ERRATA

Illinois Route 47 (Reed Road to U.S. Route 14) McHenry County, Illinois

Job No. P-91-101-07

August 10, 2016

**EXHIBIT 4-1
ENVIRONMENTAL INVENTORY MAP**

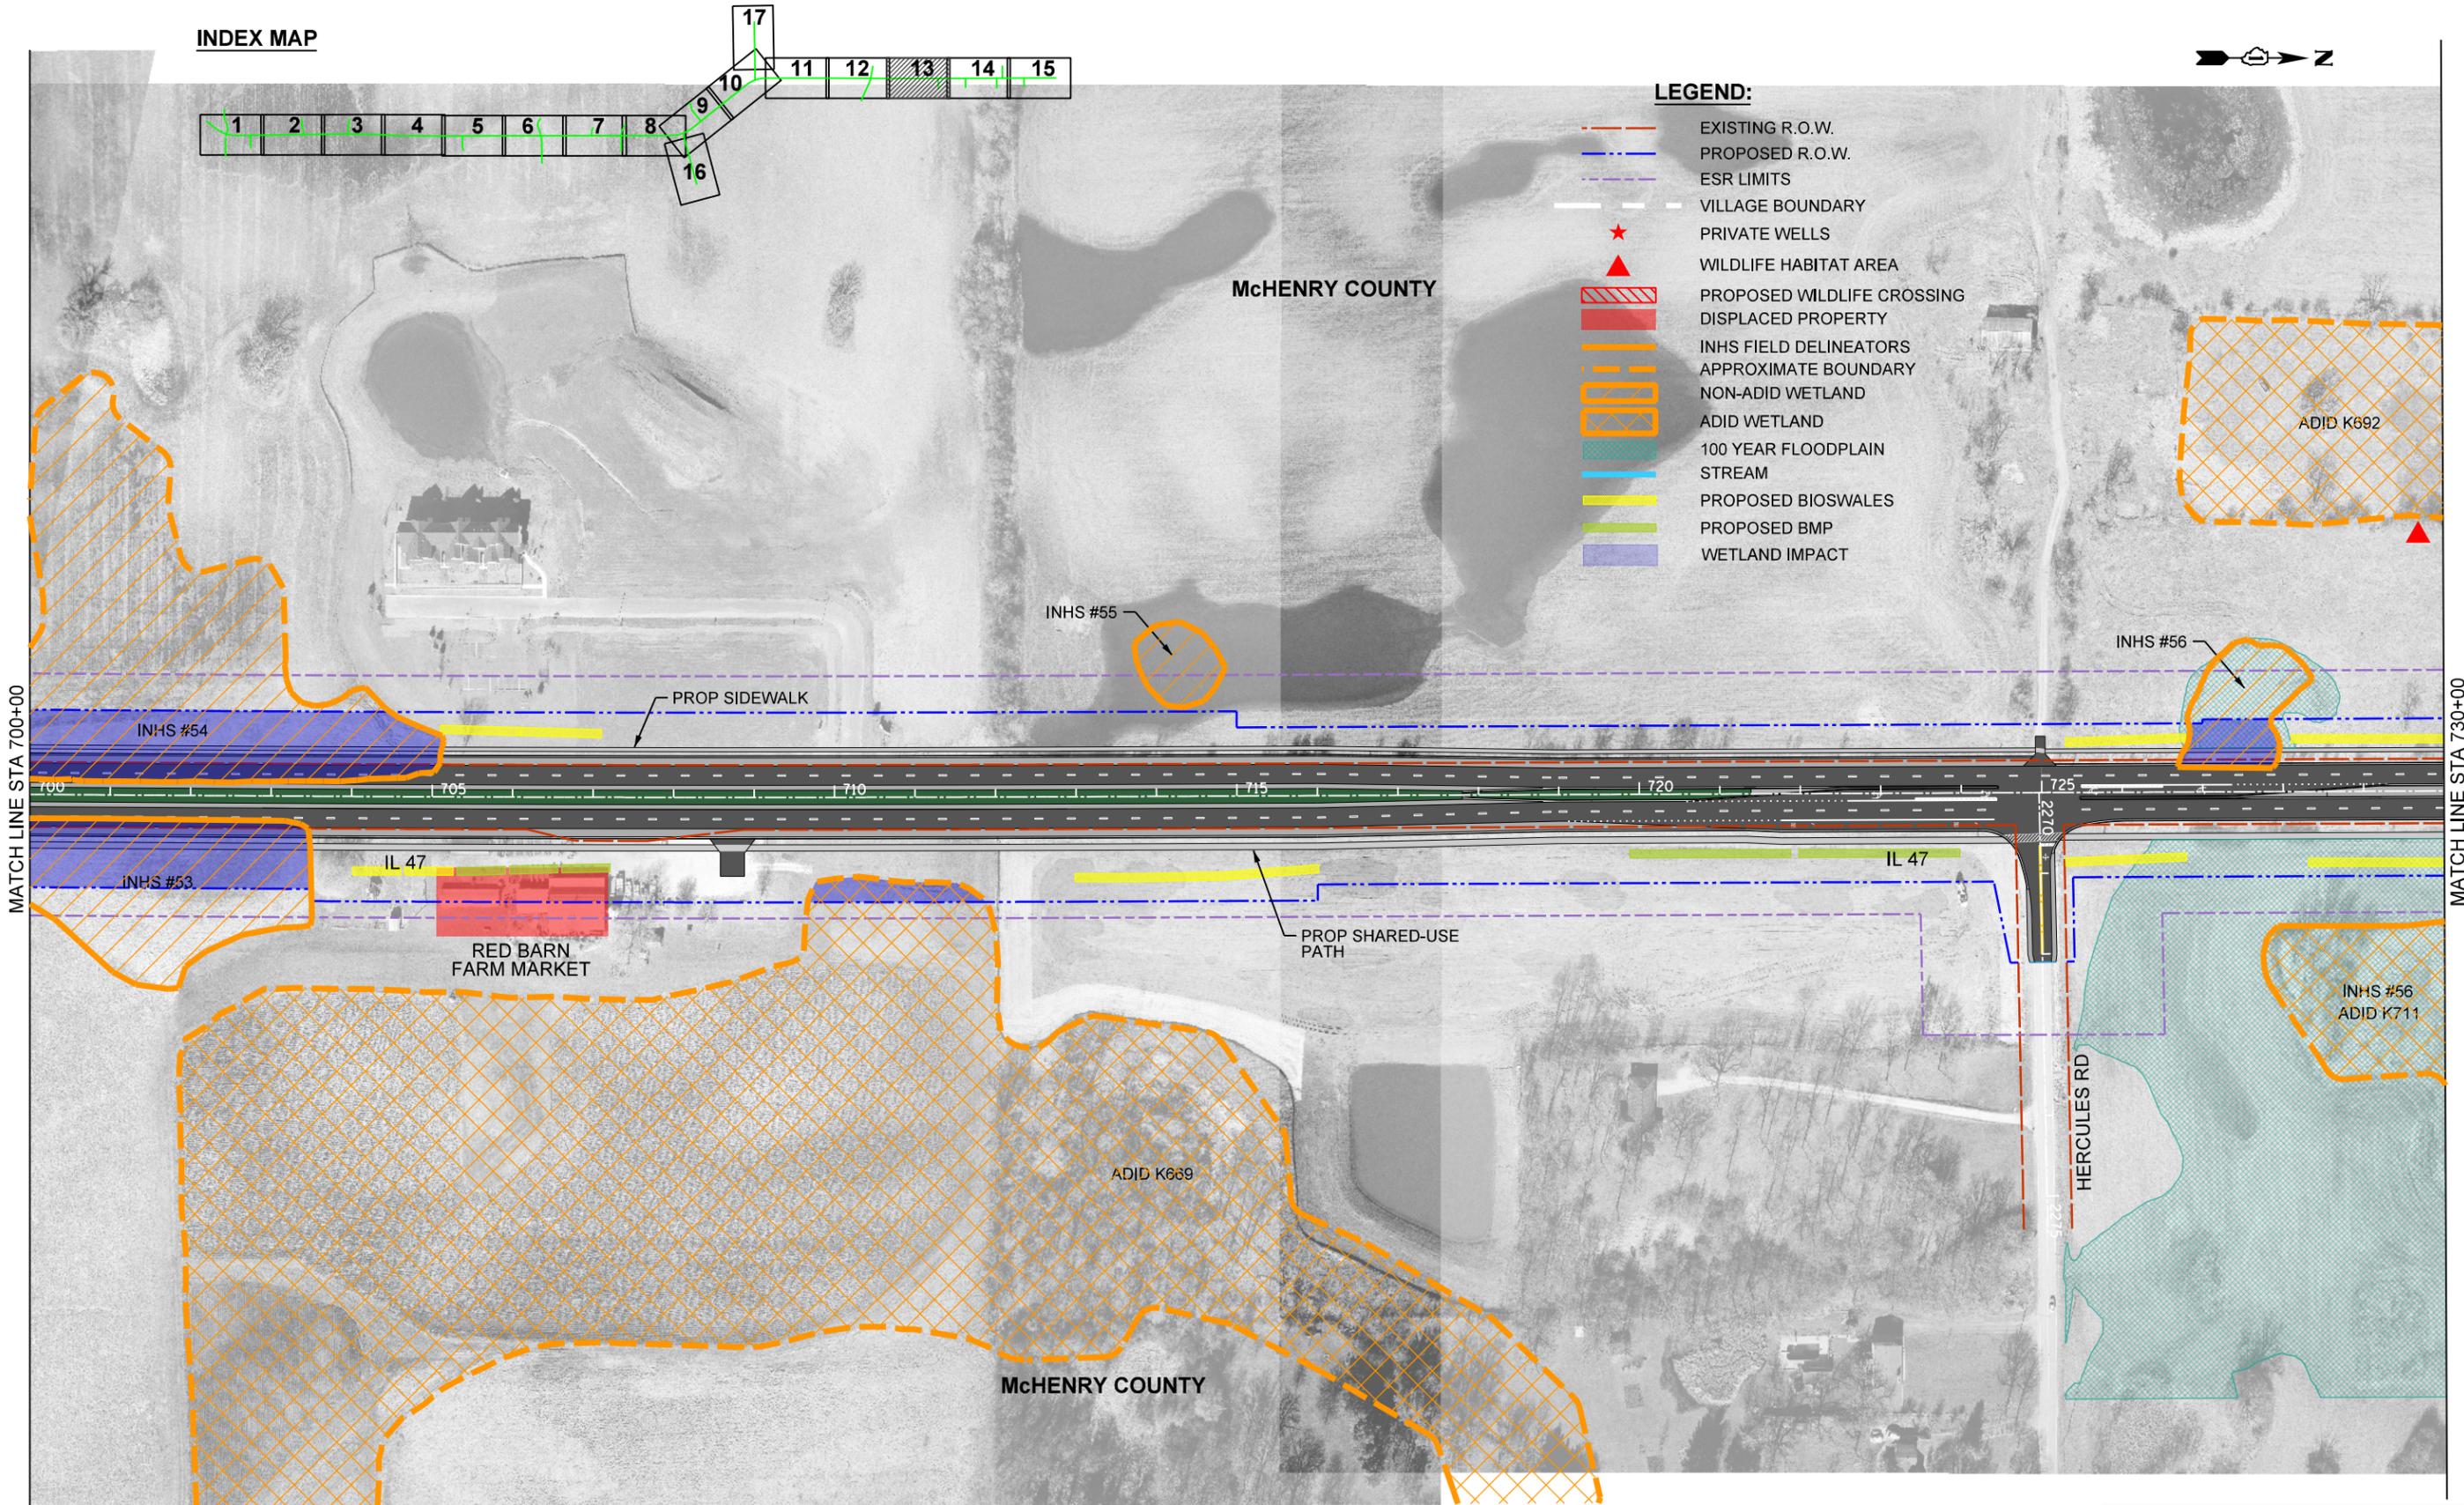
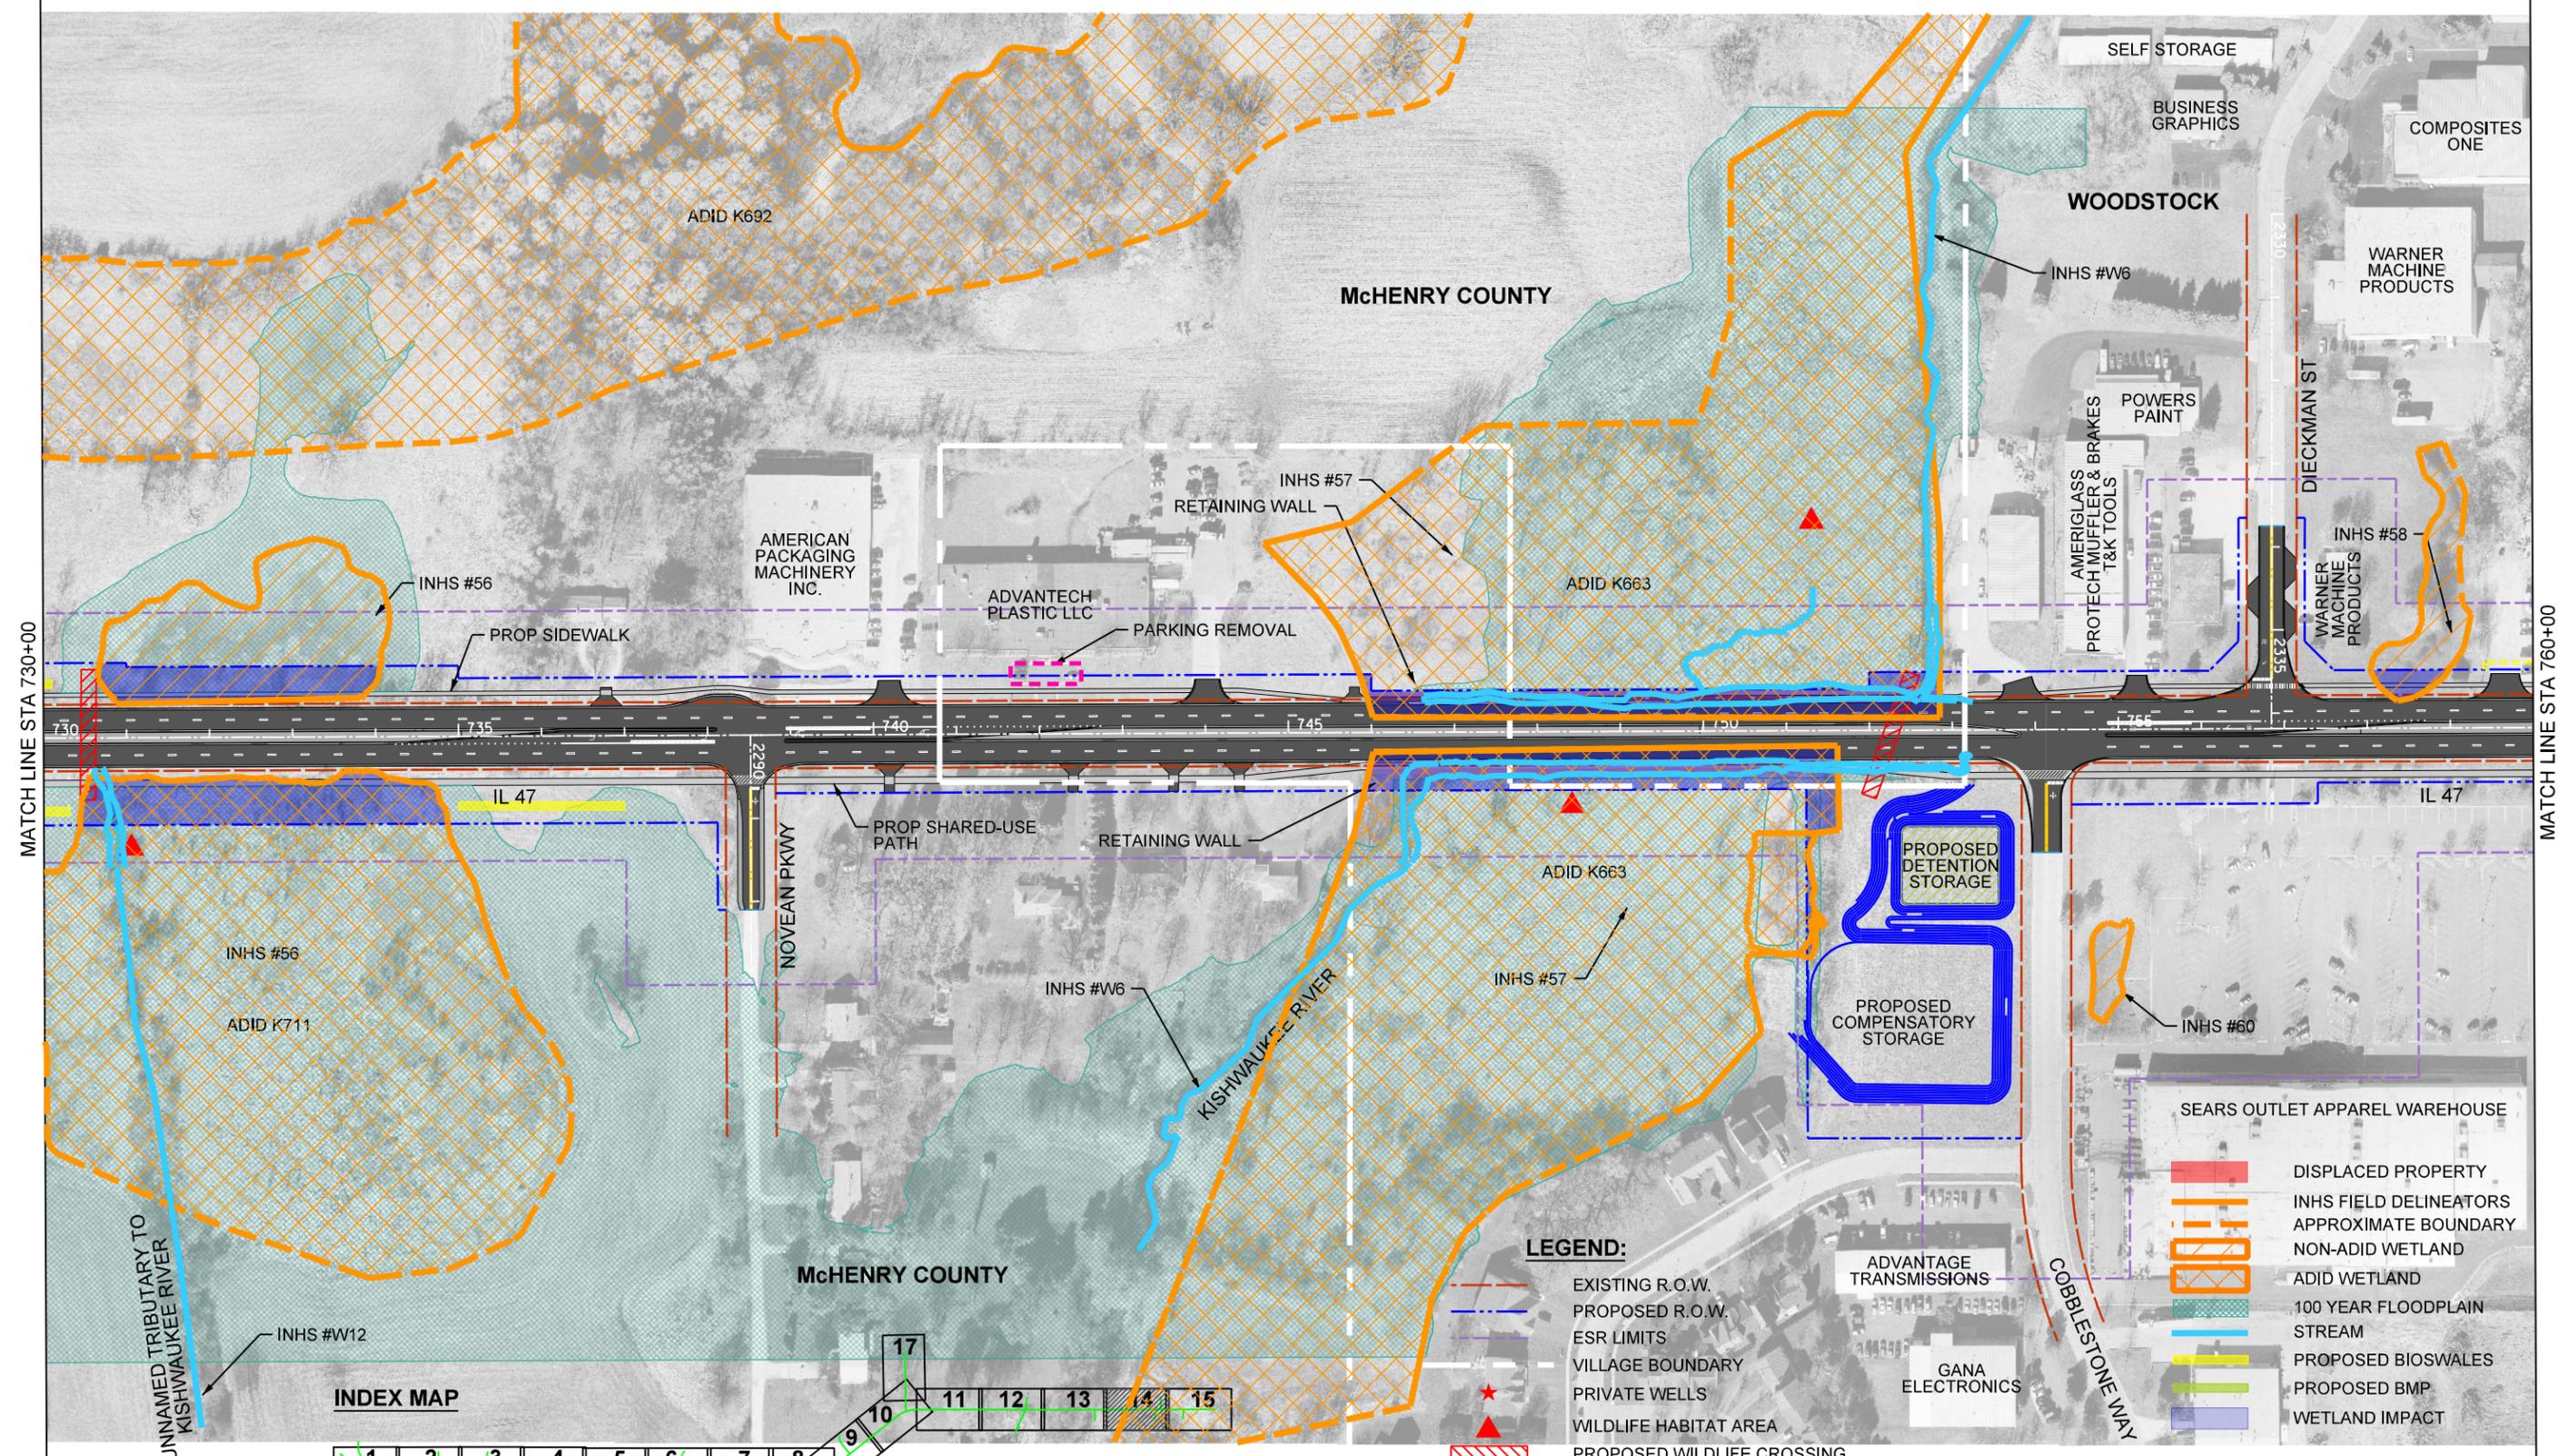
Replace Exhibit 4-1 Environmental Constraints Map to show updates to waterway names to be consistent with the Environmental Assessment, revised symbolization of the bioswales and inclusion of additional BMPs.

R	<p>A revised exhibit with a non-conflicting color scheme has been included in the Errata.</p>
87	U.S. Army Corps of Engineers	C	<p>The bioswale locations in Exhibit 4-1 should not be located within delineated wetlands or streams. Exhibit 4-1 should be revised accordingly for the final EA;</p>
		R	<p>The exhibit has been revised showing potential new locations as necessary. However, since the wetland impacts were considered to be everything within the ROW, those areas are proposed ditch locations where BMPs or bioswales are proposed; there may no longer be a functioning wetland due to construction disturbance. The design engineers will consider where regrading for the roadway and ditch work will take place while minimizing any impacts. However, there will be situations where the wetland will be graded out as part of the roadway and/or ditch construction, but these locations may be replaced with a bioswale.</p>
